# **SWEETGREEN NJ147**

Tuesday, June 14, 2022

7 Remarks Identified

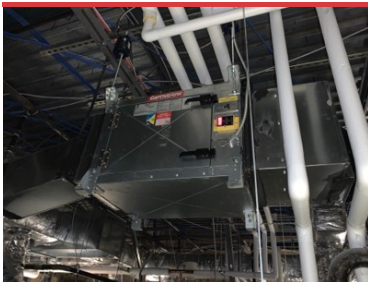
### **RTU1/2 NOTE**

OCC was not wired so temporary jumper is installed.  
Recommend connecting OCC to proper terminal on the thermostat

### **RTU1-2 FILTERS ARE HEAVILY LOADED**

Need 4 per unit 20X25X2

8 Total
